PROJECT: Esperanza - Summerlin V23A Parcel M

SUBMITTAL: 1st

CITY OF LAS VEGAS		DATE:
INTER-OFFICE MEMORANDUM		May 24, 2012
TO: Land Development Services Department of Public Works		FROM: Albert Sung, P.E. Flood Control Project Engineer Department of Public Works
SUBJECT:	Drainage Study for:	
	Esperanza – Summerlin V23A Parcel M	
Cross Streets:	NWC of Desert Moon Road & Fox Hill Drive	
File Number:	F:\Depot\DSMemos\DS4555A.doc	
Parcel Number:	137-34-313-002	
Zoning Action:	TMP-44928	
FEMA Flood Zone	YES	NO X
Proposed Storm Drain	YES	NO X
COPIES TO:		
		Slater Hanifan Group
		Greystone Nevada / Lennar Homes
		Bart Anderson, P.E., DevCo

Street Section A
Worksheet for Irregular Channel

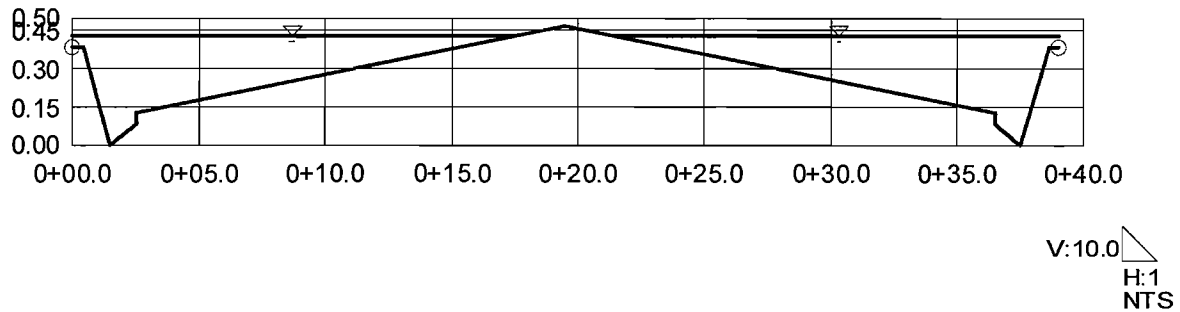
5. Excerpt from Page 10 of the Study:

“Note the following regarding the interior street sections:

- *Street Section A has been analyzed to show the amount of flow conveyed in the south half of Delano Avenue that has been designed to discharge out the site entry road into Desert Moon Road toward the existing 17.5 drop inlet.....”*

Unless Desert Moon Road is a cross fall street, the flow out from the subject development will not cross the center line to the existing 17.5 drop inlet which locates on the other half of the street. Verify whether Desert Moon Road is a cross fall street with cross section in the next submittal.
